**REPORT ON**

**VISIT TO POLARIS MINE  
NOVEMBER AND DECEMBER 1995**

Cominco Ltd.  
Polaris Operation  
Polaris, NWT  
XOE 0Y0

May 31, 1996

Figure 6

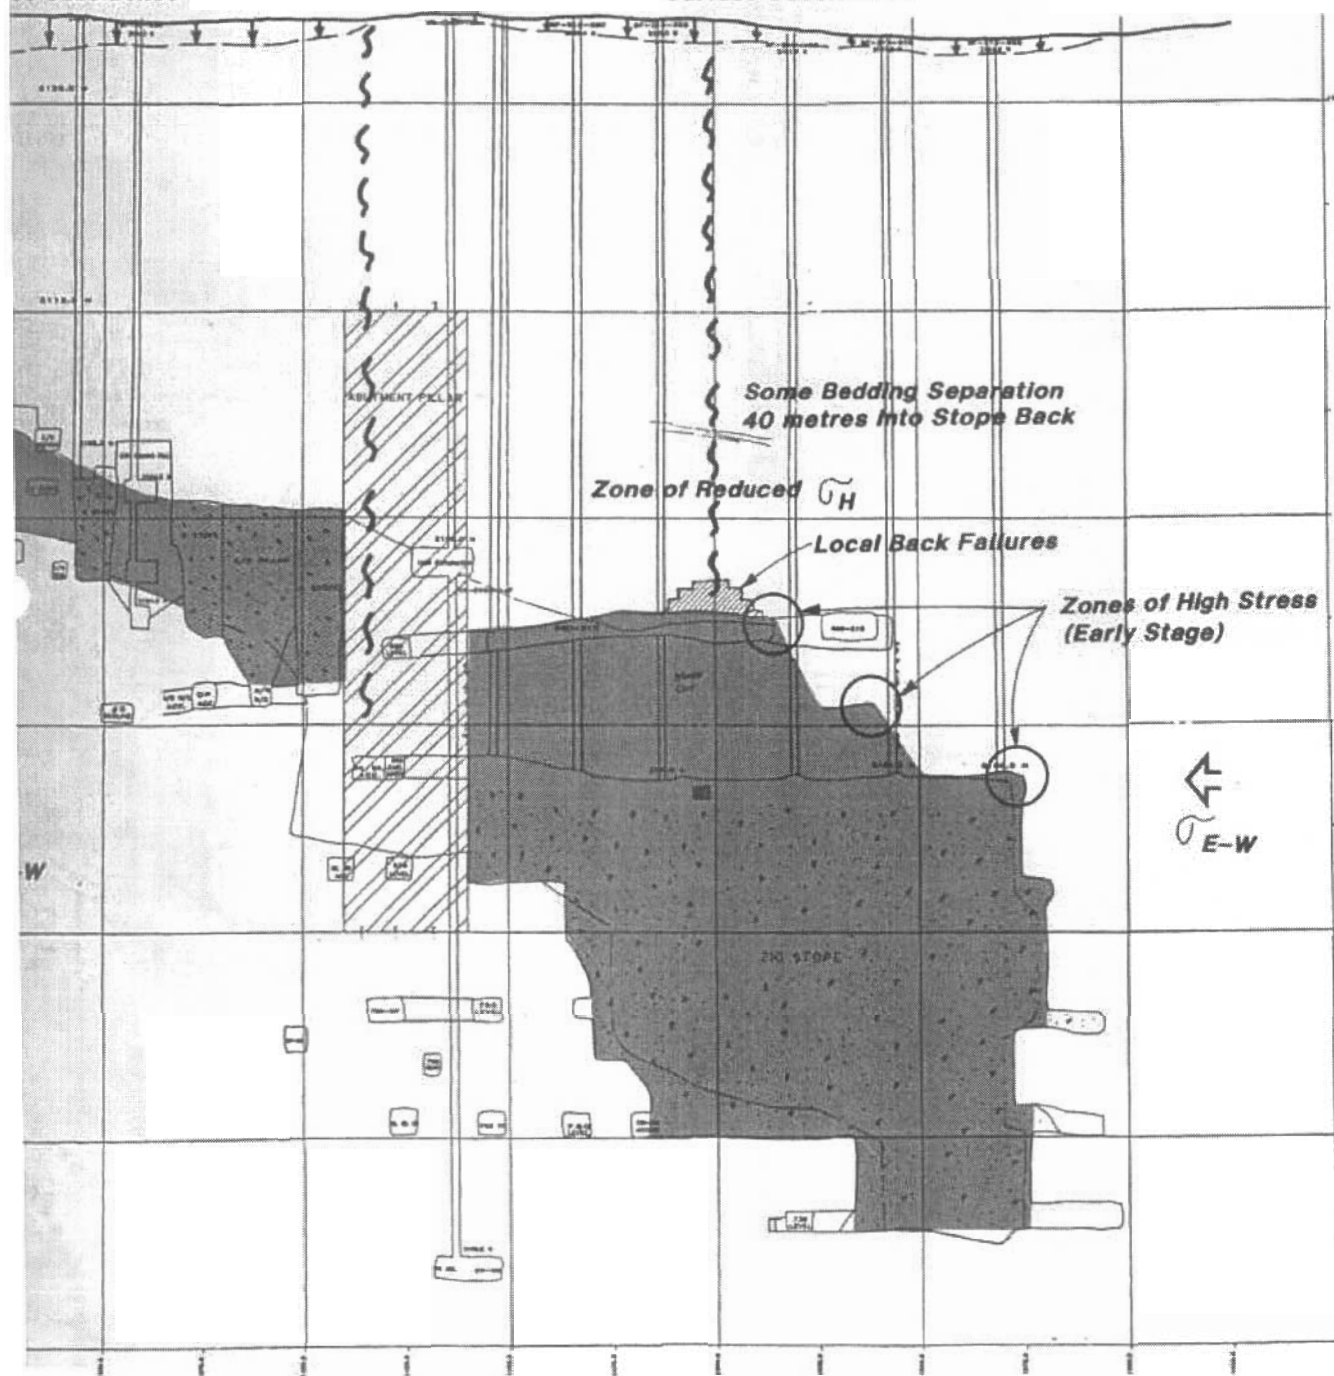
Surface monitoring shows continuing ground movement (see Figure 6). The maximum *measured* subsidence is approximately 1.25 m and is located over the 189 pillar area.

- Most subsidence monitors are maintaining constant velocity or de-accelerating.
- Analysis by mine staff of the monitoring data suggest an angle of draw of 40°.
- Given the location of the surface cracking, the angle of cave along the east and western sides of the orebody may be about 20° to 30°.
